Service Bulletin

Bulletin No.: PI0762B

Subject: Coolant Leak at Water Pump

Models: 2011-2012 Chevrolet Cruze
Equipped with 1.4L Turbo Engine (RPO LUJ)

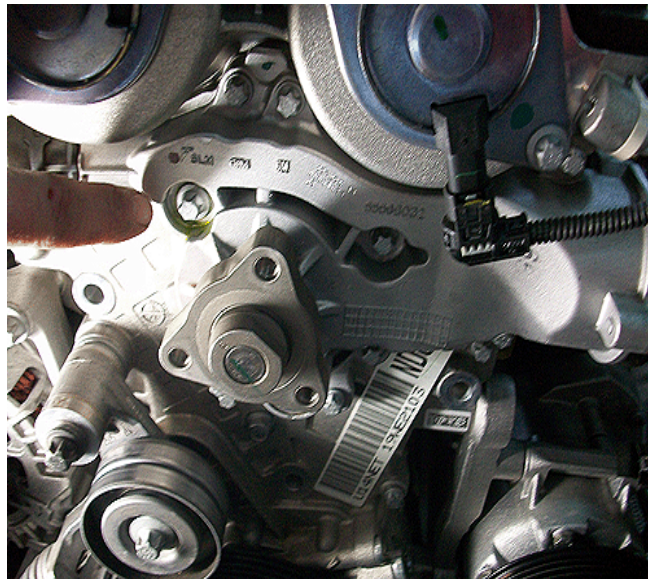
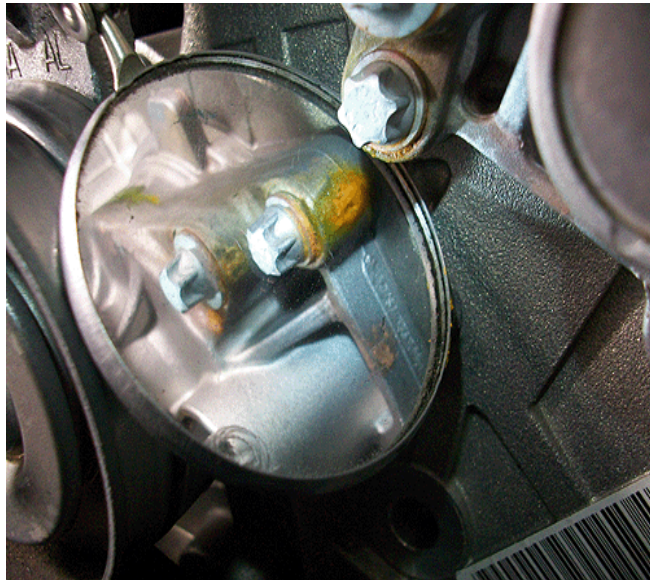
Coolant may be leaking from the water pump mounting bolts.

If the water pump mounting bolts are leaking, do not attempt to tighten or put sealer on the bolts. The water pump and gasket should be replaced.
